CITY OF FRANKLIN
PLAN COMMISSION MEETING*
FRANKLIN CITY HALL COUNCIL CHAMBERS
9229 W. LOOMIS ROAD, FRANKLIN, WISCONSIN
AGENDA
THURSDAY, APRIL 22, 2021, 7:00 P.M.

REPORT TO THE PLAN COMMISSION

6 DUMPSTER WALL SECTION
1/2" = 1'-0"

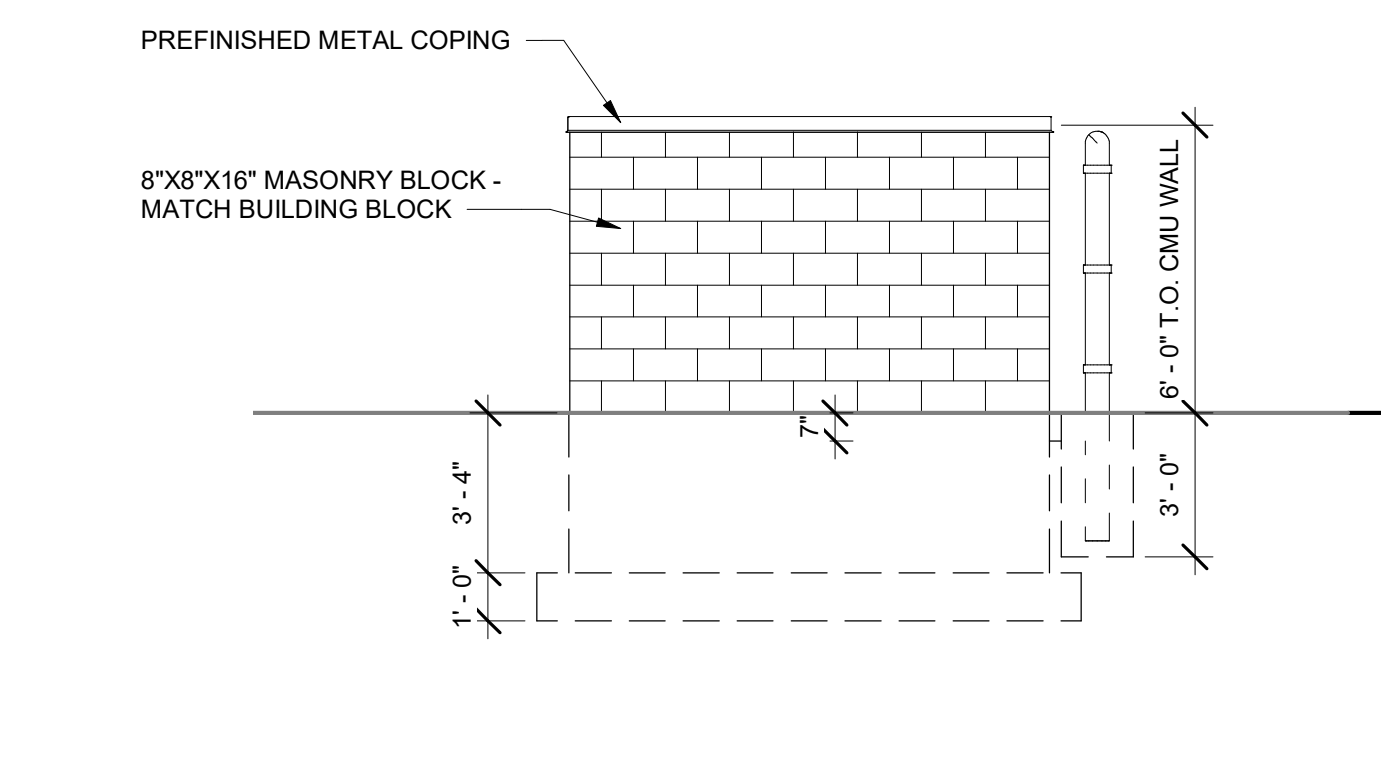
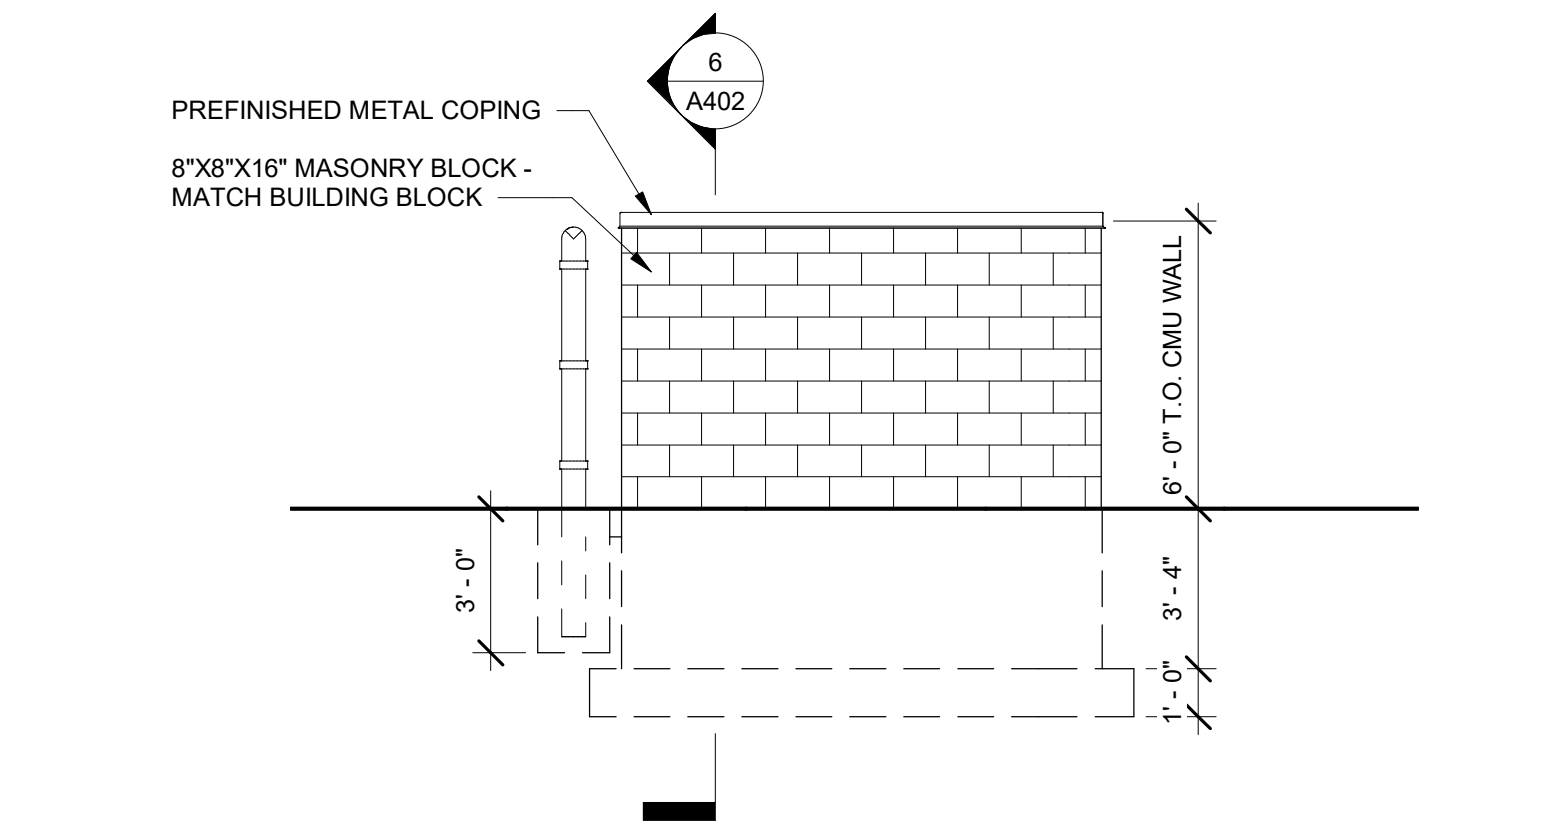
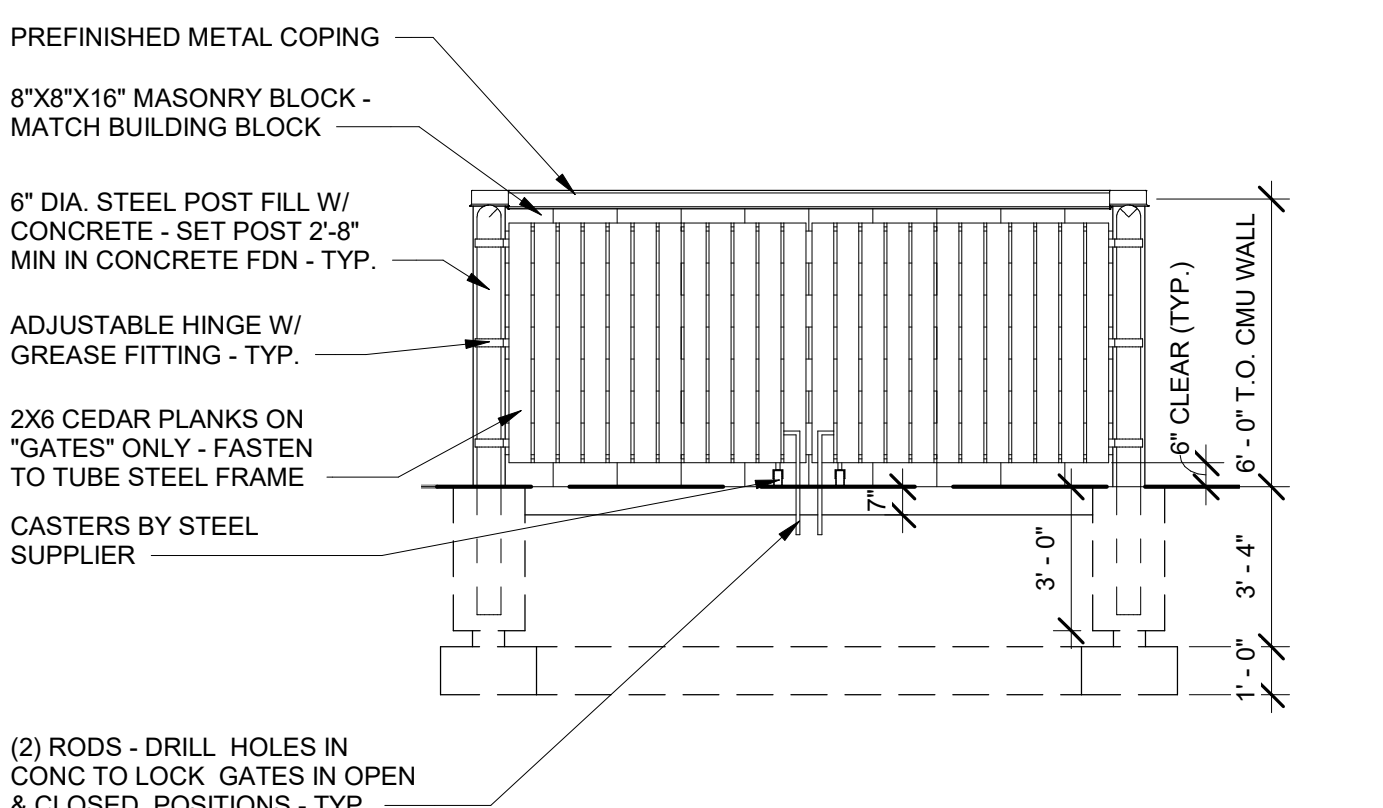
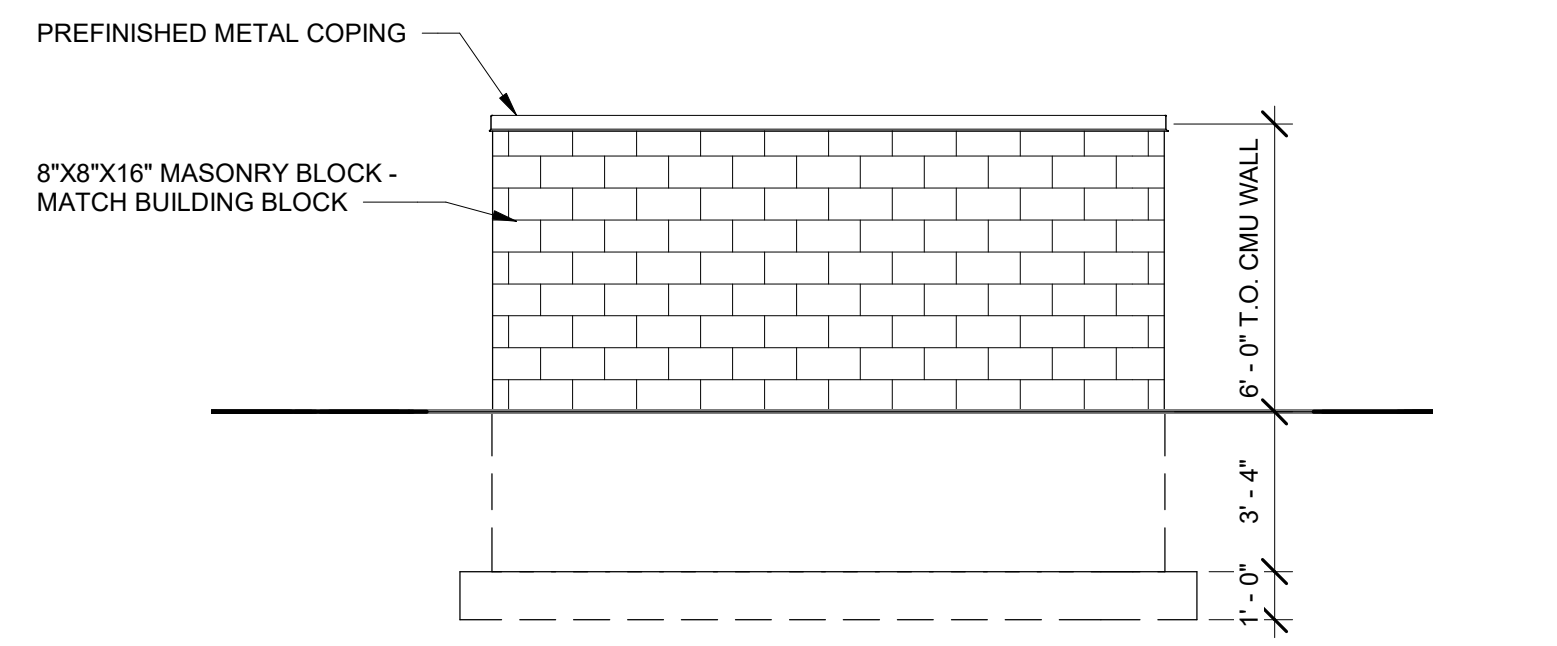
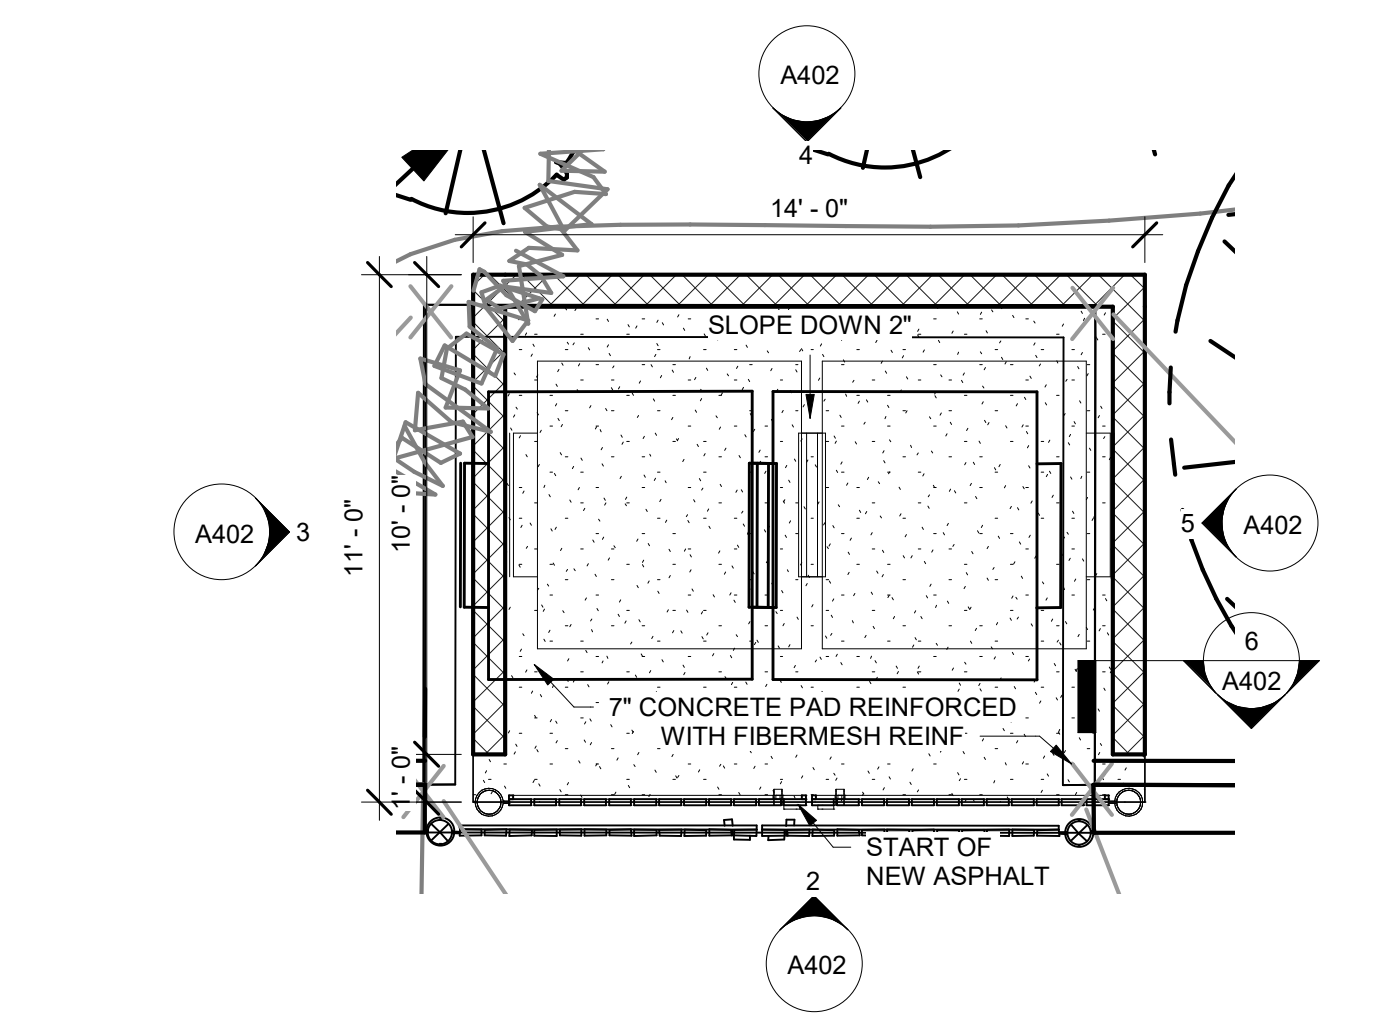
Staff comment: The dumpster would be enclosed by 6-foot walls but the gate would be visible from West Rawson Avenue. This gate would be made of steel frames with cedar planks.
